# SERVICE BULLETIN

**Service Bulletin No.:** DAC1-31-01 Rev 0

**Title:** Removal of OAT/Clock AA Battery

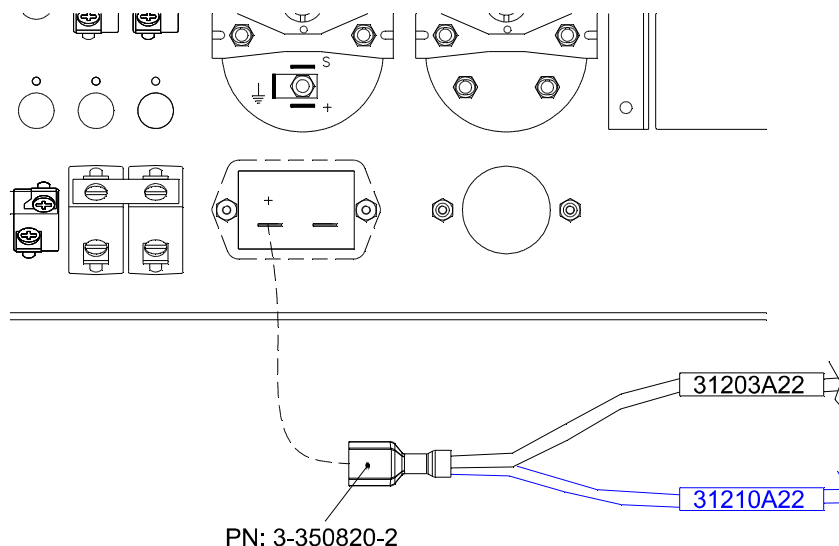
- 10.4** Prepare new wire as shown below. Use permanent marker to record wire code.

- 10.5** Install new wire into pin 9 of OAT/Clock connector (J3120-02).
- 10.6** Route new wire along existing harness to hourmeter and secure with supplied cable ties.
- 10.7** Cut new wire 31210A22 to length to plug into '+' contact of hourmeter.
- 10.8** Install second supplied label to wire end and record wire code 31210A22 using permanent marker.
- 10.9** Remove faston from wire 31203A22 and crimp together with new wire 31210A22 using supplied faston.
